POLICY REPORT
DEVELOPMENT AND BUILDING

Report Date: July 13, 2015
Contact: Susan Haid
Contact No.: 604.871.6431
RTS No.: 11020
VanRIMS No.: 08-2000-20
Meeting Date: July 21, 2015

TO: Vancouver City Council
FROM: General Manager of Planning and Development Services
SUBJECT: CD-1 Rezoning: 7510-7554 Cambie Street

Figure 2: Landscape / Site Plan

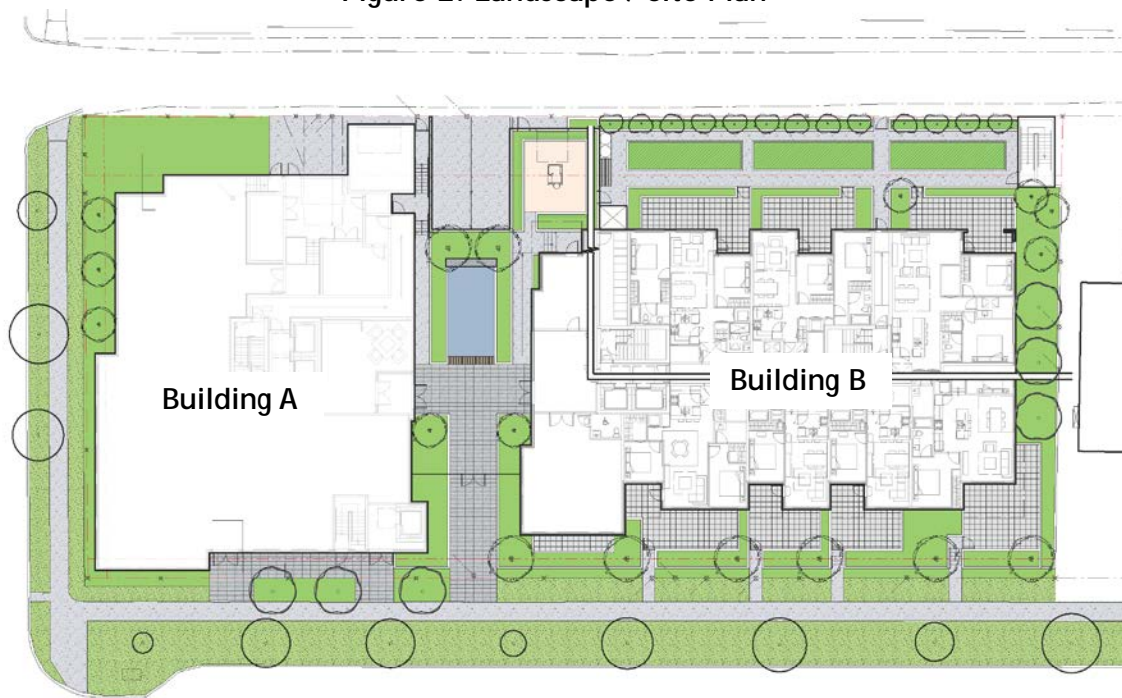
- (i) Provide improved pedestrian and visual connectivity through the courtyard.

Note to Applicant: The courtyard amenity space should read as continuous from Cambie Street to the rear lane. To this end, the locations of the parkade entry ramp and children's play area may be flipped. More generous stairs/terraces may be provided to connect down to the lane, and additional landscape features to better identify the courtyard entry from the lane. The vista room and loading space may be setback to provide more open space at the base of the stairs. While the courtyard is not required to be a public thoroughfare, the proposed full height security gates are not supported. Low, discrete, highly transparent, and visually attractive gates may be provided, more in keeping with a pedestrian scale.

- (ii) Expand programming of the courtyard to provide usable outdoor amenity space.

Note to Applicant: As currently proposed, the courtyard serves largely as circulation space and as a visual amenity, and should incorporate more active and engaging amenity spaces. The proposed planters at the perimeter should be deleted to allow for direct access to the courtyard from amenity rooms and the commercial unit. Pockets of residential seating and trees/planting should be provided instead, as well as commercial patio space. Planting should be at grade (not raised), which will require a deeper parkade excavation. The proposed water feature should be deleted and a more active use provided at the rear, such as

- 2. Design development to provide an improved interface with the lane at the base of the residential building.

Note to Applicant: This may be achieved by providing a distinct entry gate and path to each ground floor unit through the common urban agriculture space. A tree should be located flanking each patio as a privacy buffer and to provide unit identity.

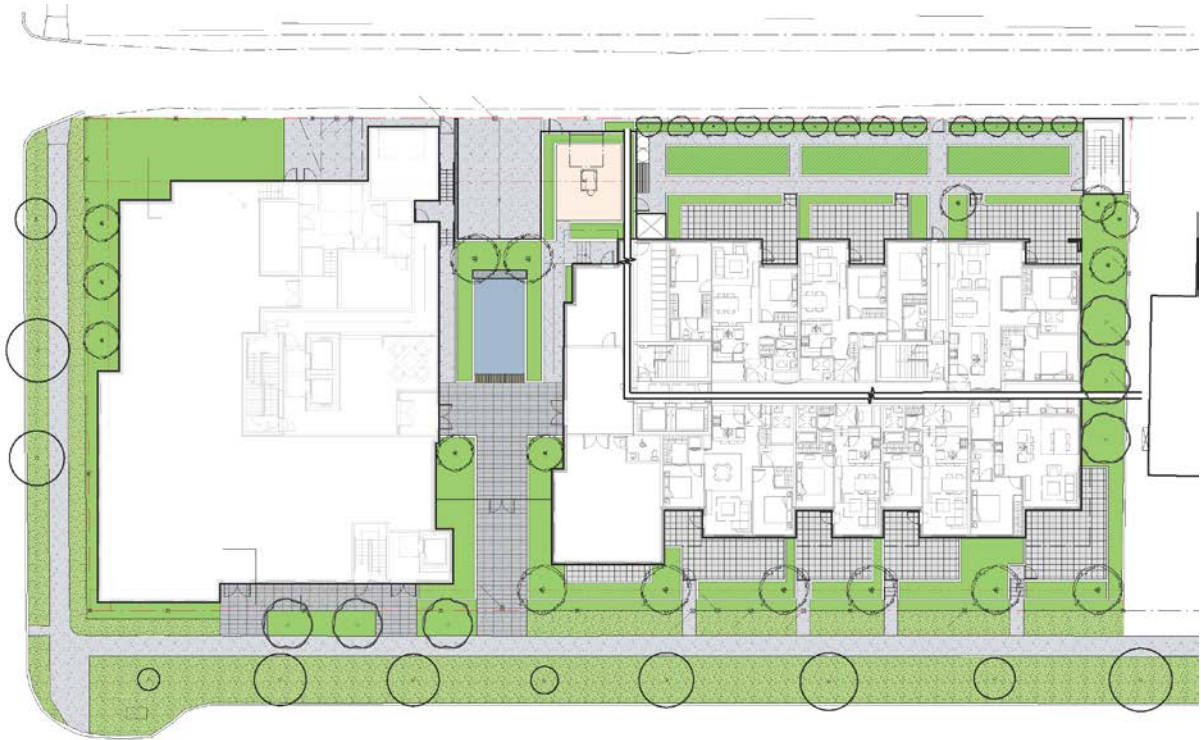
lack of sunlight in the courtyard and suggested a more consistent approach for the 4-storey step up for the soulade.

Some Panel members did not support the basement units as they thought they created a sunken courtyard and that the units would not get a lot of natural light. As well it was noted that this level created a 7-storey expression along the lane which is not consistent with the Cambie Corridor Plan.

The Panel supported the landscape plans but some Panel members wanted to see a continuous pedestrian connection through the site. They liked how the amenity space spanned from the street to the lane. However they thought the shortcoming was that the amenity didn't engage the courtyard and wanted to see more patio space. As well they noted that the children's play was disconnected from the amenity. One Panel member was concerned with the stair well as they thought it took away from the courtyard space. Some Panel members thought there needed to be more of a connection from the private patios to the lane and wanted to see room for larger trees in the lane as well.

Although some Panel were not opposed to the entrance to the parkade they thought pulling back the vista switch and the garbage and having two sets of stairs would make for better access for pedestrians through the courtyard. Pulling away the vista switch would make more room for a landscaped edge rather than having it stop at the ramp.
